LUND RANCH II
PUD-25
1500 LUND RANCH ROAD

STATE CLEARINGHOUSE # 2003092021

FINAL ENVIRONMENTAL IMPACT REPORT
COMMENTS AND RESPONSES

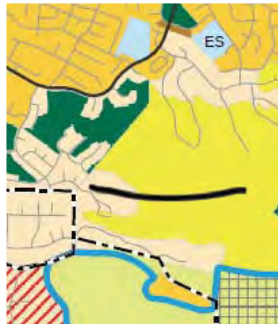
10. Page 4.1-2 and Figure 4.1-1: As mentioned previously, the General Plan Land Use Element map in the DEIR is different than the one on the Pleasanton city web page. The southeastern corner of the property for Lund Ranch II is clearly a light green which is Public Health and Safety. Please correct the DEIR and place the correct General Plan Land Use Map in the DEIR. See the portion of the Land Use Map from the General Plan below.

Response to Comment O-3 Ridge and Hillside Protection Association - 15: Please see Response to Comment O-4 Ridge and Hillside Protection Association- 02 above.

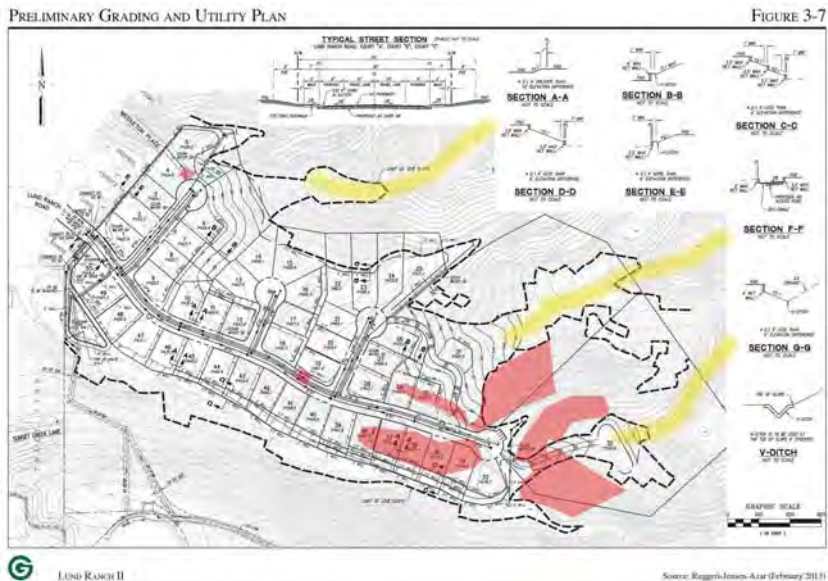
I reviewed both the preliminary grading plan drawing (page 52) and the slope map (page 68) for compliance to the 25% rule. To check for compliance with the 25% rule, I used an averaging method which uses a 40' linear dimension. If there are five or more contour lines that occur in that 40' length as measured perpendicular to the contours, then the slope is more than 25%. This method is perhaps more generous than other methods proposed, but it tends to eliminate small slope inconsistencies.

Using this method, I found that 12 of 52 lots appear to violate the PP rule prohibiting development on slopes greater than 25%. Those lots are 4, 5, 29, 30, 33, 34, 35, 36, 37 and 38. There is a note on the drawing on page 68 about man-made slopes being exempt from PP, but as you can see in the text of the initiative, there is no such exemption provided for. Such exemptions can not be created without going to a public vote. Additionally, the service road between the courts behind lots 26 and 30 crosses slopes

Response to Comment I-48 Roberts - 01: The comment provides an alternate interpretation of methods to be used in the determination of slopes for project evaluation. The Slope Map, Figure 4.1-3 on Draft EIR page 4.1-13, was prepared by Ruggeri-Jensen-Azar (RJA), a civil engineering firm that has extensive experience in civil engineering and land surveying. The 25% slope limit line has been considered by City decision makers to be a nominal value (Figure 3-2, page 3-6 of the Draft EIR) and to provide sound direction to the applicant's consulting engineers for the project's design. City decision-makers considered the merits of a slope averaging formula in locating the 25% slope line, and rejected it as not compliant with Measure PP, because a slope averaging formula would potentially allow development in areas with slopes that exceed 25%.

FIGURE 5-3

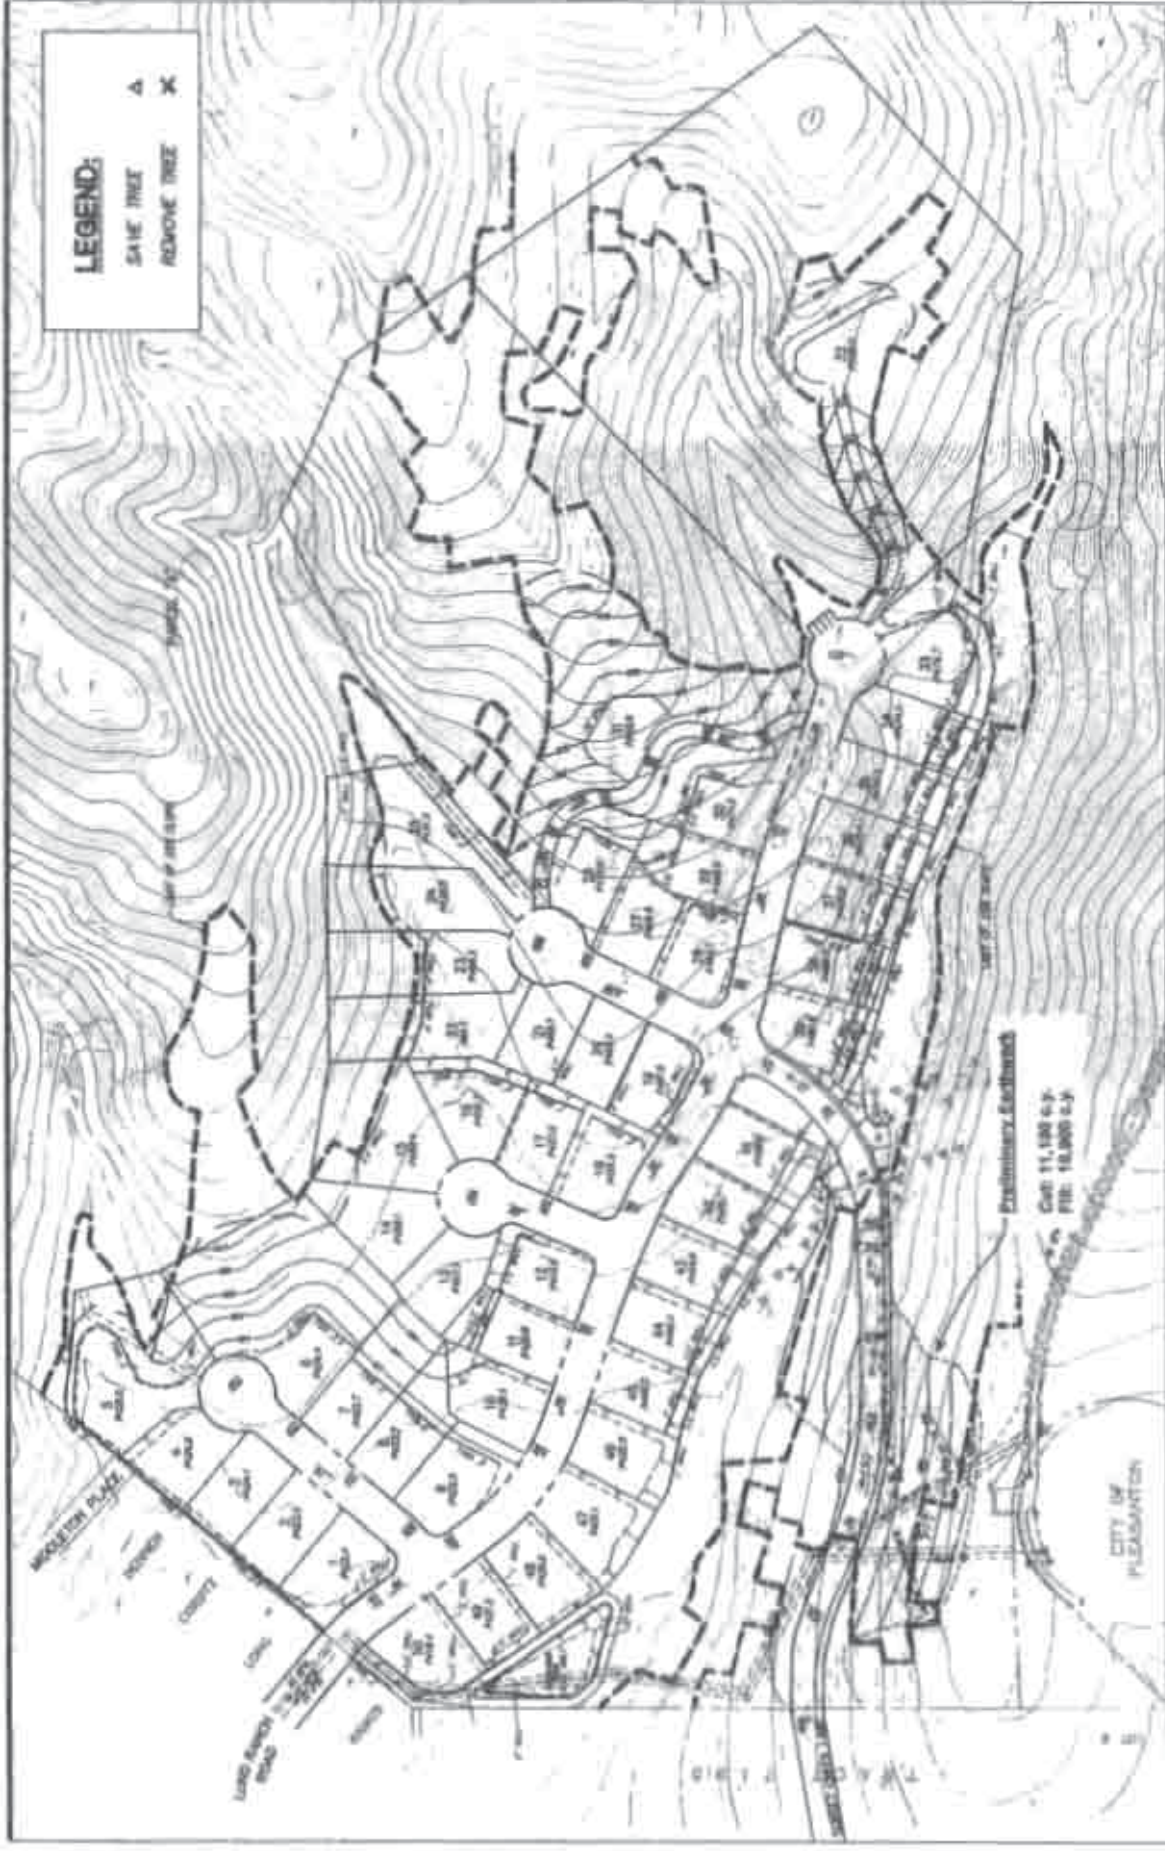
reduced scale map at Figure 5.3 of the DEIR (Attachment 3). According to that site plan, there is only a 10 foot elevation change from Sunset Creek Lane to the Greenbriar project. That road connection follows the hillside contour for most of its length, with a gentle slope overall – a very functional road design (Attachment 4 photo). The Sunset Creek Lane connection, as shown in Scenario 6, is the least impactful alternative consistent with the City's circulation plan of having Lund Ranch II take its traffic access through the North Sycamore area.
